ATTACHMENT 1

Marked-up St. Lucie Unit 1 Technical Specification Pages:

3/4 4-17  
3/4 4-18  
B 3/4 4-5  
6-16 (with insert)

Marked-up St. Lucie Unit 2 Technical Specification Pages

## 3/4.4.8 SPECIFIC ACTIVITY

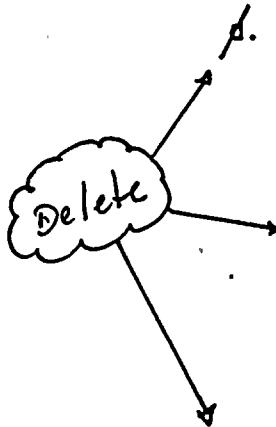
~~a. With the specific activity of the primary coolant greater than 1.0 microcurie/gram DOSE EQUIVALENT I-131 but within the allowable limit (below and to the left of the line) shown on Figure 3.4-1, operation may continue for up to 48 hours provided that the cumulative operating time under these circumstances does not exceed 800 hours in any consecutive 12 month period. With the total cumulative operating time at a primary coolant specific activity greater than 1.0 microcurie/gram DOSE EQUIVALENT I-131 exceeding 500 hours in any consecutive 6 month period, prepare and submit a Special Report to the Commission pursuant to Specification 6.9.2 within 30 days indicating the number of hours above this limit. The provisions of Specification 3.0.4 are not applicable.~~

Delete

With the specific activity of the primary coolant greater than 1.0 microcurie/gram DOSE EQUIVALENT I-131 for more than 48 hours during one continuous time interval or exceeding the limit line shown on Figure 3.4-1, be in at least HOT STANDBY with  $T_{avg}$  less than 500°F within 6 hours.

With the specific activity of the primary coolant greater than  $100/\bar{E}$  microcuries/gram, be in at least HOT STANDBY with  $T_{avg}$  less than 500°F within 6 hours.
